Vermont Yankee Nuclear Power Station

Proposed Technical Specification Change No. 263

Extended Power Uprate – Supplement No. 8

Response to Request for Additional Information

**Figure EMCB-A-1-1**  
**Schematic Representation of Drain Channel Cracking**

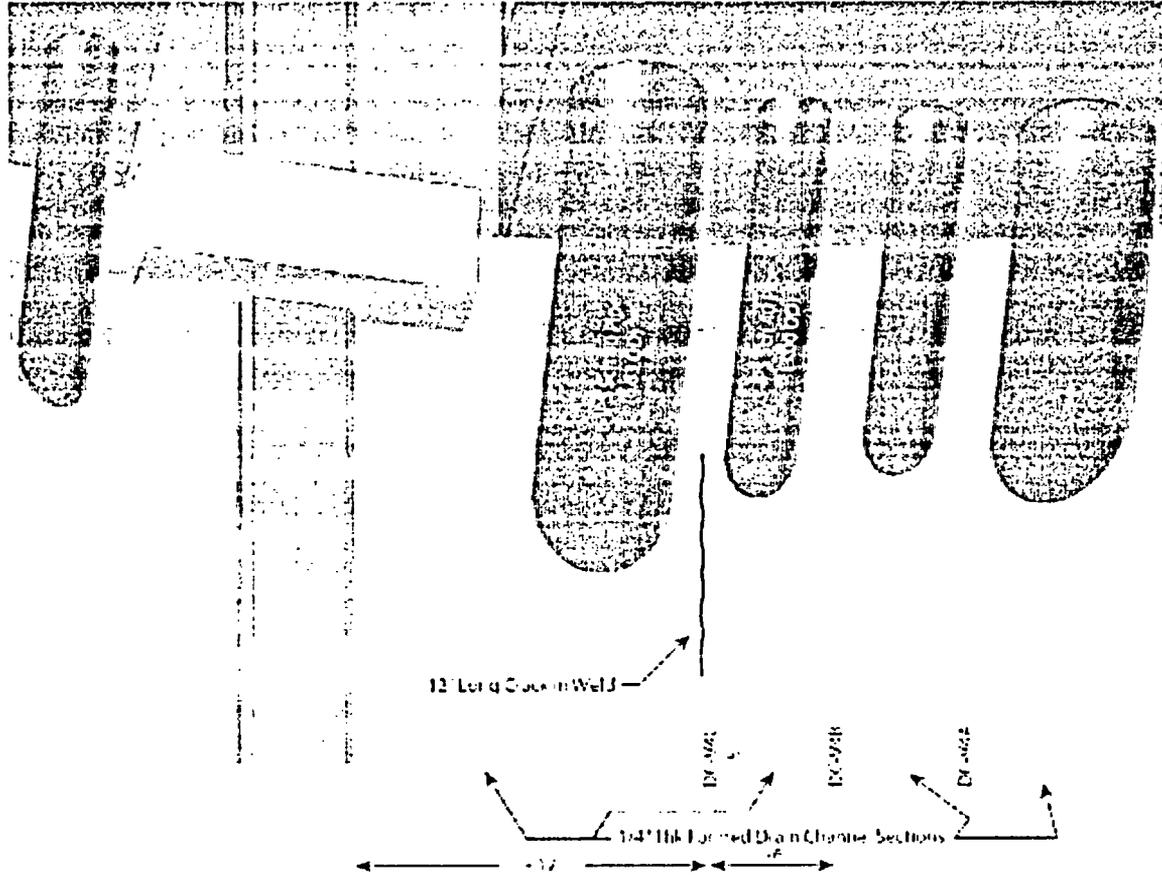
For any detected flaw in the steam dryer left unrepaired, provide a structural integrity evaluation and identify the critical flaw size for EPU conditions and the margins between the critical flaw size and the flaw size projected for the period of time that these flaws will remain inservice. The analysis should consider the potential impact on flaw growth due to the proposed EPU conditions, intergranular stress corrosion cracking (IGSCC) and fatigue. The margins should be compared to those specified in IWB-3600 of Section XI of the American Society of Mechanical Engineers (ASME) Code. An assumed IGSCC crack growth rate should be compared to those specified in NUREG-0313.

For the case of the VYNPS dryer drain channel cracking, the inspection evaluation (discussed further in the RAI response EMCB-B-2) established that this crack is IGSCC with no evidence of fatigue extension at current licensed thermal power operating condition. It is located in the heat-affected-zone adjacent to the weld and follows the grain boundaries, exhibiting a jagged appearance. The crack is not straight and does not have any characteristics of a fatigue crack. Figure EMCB-A-1-1 schematically shows the length and location of the 12 inch IGSCC crack. The initial engineering assessment dispositioned the flaw based on qualitative factors: (1) the drain channel flaw is in the non-structural portion of the dryer (i.e., they are not located in the skirt structure itself), (2) the drain channel flaw is only 13% of the length of the weld, (3) there is a lack of any field experience of drain channel cracking extending the entire length of the weld and (4) a postulated full length crack extending the full length of the weld if postulated to propagate by fatigue during future operation, would still not generate a loose piece. Two sides of the skirt plate and the pipe attachment provide enough structure to maintain integrity of the cracked location. The field experience supports the as-is operation decision, particularly in the context that the indication will be re-inspected at the next outage. However, in order to address the request for a structural analysis, the IGSCC flaw was also assessed quantitatively.

Figure EMEB-B-2-1  
 VYR24-04-01 Indication Locations

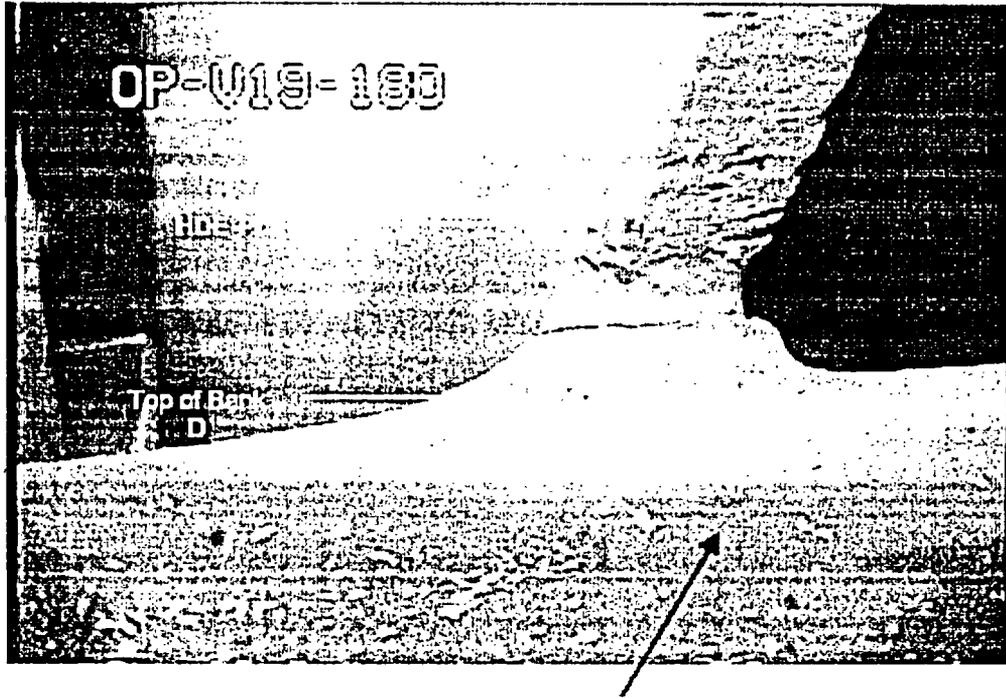
On April 21, 2004, Entergy briefed the NRC in a conference call with regard to the results of the steam dryer inspection performed during the Spring 2004 outage. Since the steam dryer inspection provides extensive baseline information, the licensee should discuss in detail the cause of each identified crack indication and docket the results of the inspection, including justification of why the results are acceptable with respect to the proposed EPU. It is noted that Quad Cities (QC) did not have a notable dryer failure until after operating at the EPU power level. QC2 has the square type of steam dryer with the internal brace at the outer hood which has failed three times since operating at the EPU power level. The steam dryer at VYNPS is the same design as those at QC. Describe the validation of the steam dryer analysis at VYNPS in successfully predicting steam dryer cracking identified during the Spring 2004 outage.

Indications were found at diametrically opposed locations on the exterior steam dam. Figure EMEB-B-2-1 is a schematic of the locations with respect to the overall dryer.

The first indication was found in welds OP-V19-180 and V02-270. These welds are located at the 215-degree azimuth of the dryer, behind lifting lug "C". Figure EMEB-B-2-2 shows the indication along the top region of the fillet welds joining plate HDE-PL3 and dryer Bank "D". The indication started near the top of V02-270, continued over the top and around the end of the HDE-PL3 plate and proceeded into weld OP-V19-180. The total length of the indication was approximately 3-inches long.

The second indication was found in welds OP-V19-0 and V02-90. These welds are located at the 35-degree azimuth of the dryer, behind lifting lug "A" (diametrically opposite the first indication described above). Figure EMEB-B-2-3 shows the indication along the top region of the fillet welds joining plate HBE-PL2 and dryer Bank "B". The indication started near the top of V02-90, continued over the top and around the end of the HBE-PL2 plate and proceeded into weld OP-V19-0. The total length of the indication was approximately 3-inches long.

VYNPS Overpressure Credit for NPSH DBA LOCA-Long Term

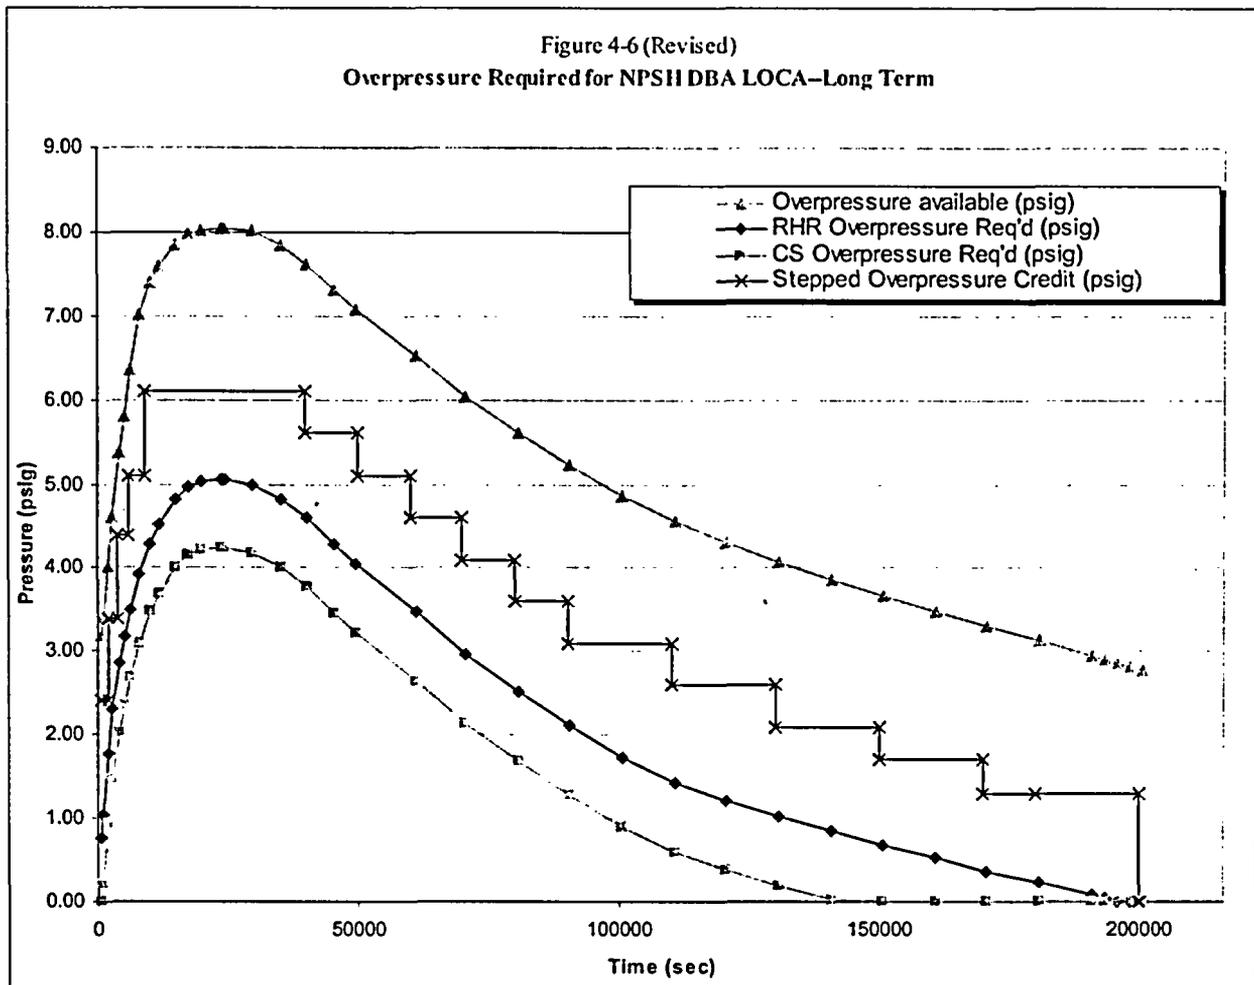
The application dated September 10, 2003 (Reference 1), Attachment 6, Table 4-2 and Figure 4-6, show that the containment accident pressure requested for adequate available NPSH is 1.3 psig at 50 hours. When is containment accident pressure no longer required?

Revised Table 4-2 and Figure 4-6 are enclosed. The overpressure credit requested has not changed. The time after LOCA has been extended from 180,000 seconds to 200,000 seconds.
